RENESAS TECHNICAL UPDATE

Product Category	MPU/MCU		Document No.	TN-V85-A015A/E	Rev.	1.00
Title	V850E/IA1,V850E/IA2 Usage Restriction about bus control function.		Information Category	Usage Restriction		
Applicable Product	V850E/IA1,V850E/IA2 series	Lot No.	Reference Document	* V850E/IA1 User's manual V850E/IA1 and 32-bit single chip micro controllers hardware volume (the 6rd edition) (U14492EJ6V0UD00)		
		All lots		*V850E/IA2 User's manual V850E/IA2 and 32-bit single-chip micro controllers hardware volume (the 6rd edition) (U15195EJ6V1UD00)

The state of pins are indicated in the following timing chart.

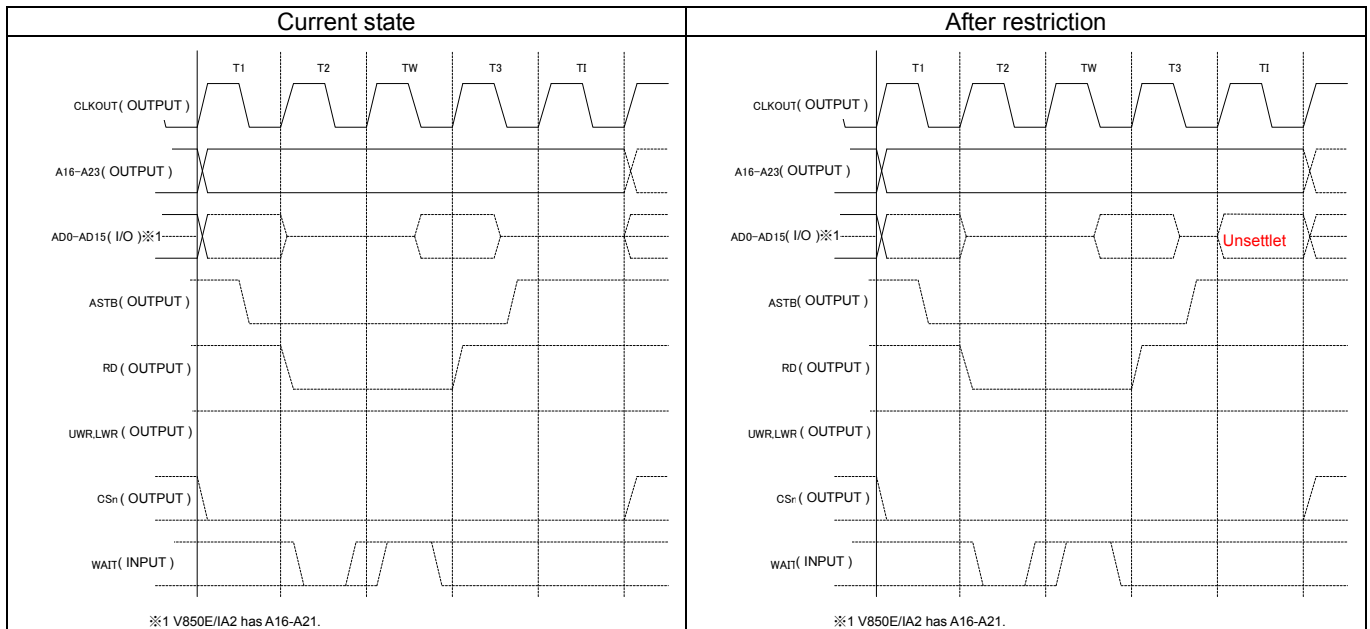
When idle state(TI) cycle is inserted to secure data output float delay time of the memory during read access, AD0-AD15 terminal will be unsettled output at that timing.

User's manual are corrected as follows.

Item	Page	Correction point	Current state	After restriction
1.	116	(1) Bus cycle Control register (BCC)	Cautions 1. Idle states cannot be inserted in internal ROM, internal RAM, on-chip peripheral I/O, or programmable peripheral I/O areas. 2. Write to the BCC register after reset, and then do not change the set values. Also, do not access an external memory area other than the one for this initialization routine until the initial setting for this register is complete. However, it is possible to access external memory areas whose initial settings are complete.	Cautions 1. Idle states cannot be inserted in internal ROM, internal RAM, on-chip peripheral I/O, or programmable peripheral I/O areas. 2. Write to the BCC register after reset, and then do not change the set values. Also, do not access an external memory area other than the one for this initialization routine until the initial setting for this register is complete. However, it is possible to access external memory areas whose initial settings are complete. 3. AD0-AD15 pins will be unsettled output in the idle state.

Item	Page	Correction point	Current state	After restriction
1.	96	(1) Bus cycle Control register (BCC)	Cautions 1. Idle states cannot be inserted in internal ROM, internal RAM, or on-chip peripheral I/O areas. 2. Write to the BCC register after reset, and then do not change the set values. Also, do not access an external memory area other than the one for this initialization routine until the initial setting for this register is complete. However, it is possible to access external memory areas whose initial settings are complete.	Cautions 1. Idle states cannot be inserted in internal ROM, internal RAM, or on-chip peripheral I/O areas. 2. Write to the BCC register after reset, and then do not change the set values. Also, do not access an external memory area other than the one for this initialization routine until the initial setting for this register is complete. However, it is possible to access external memory areas whose initial settings are complete. 3. AD0-AD15 pins will be unsettled output in the idle state.

When using the bus function, be careful so that a signal of AD0-AD15 terminal doesn't collide with idle state.
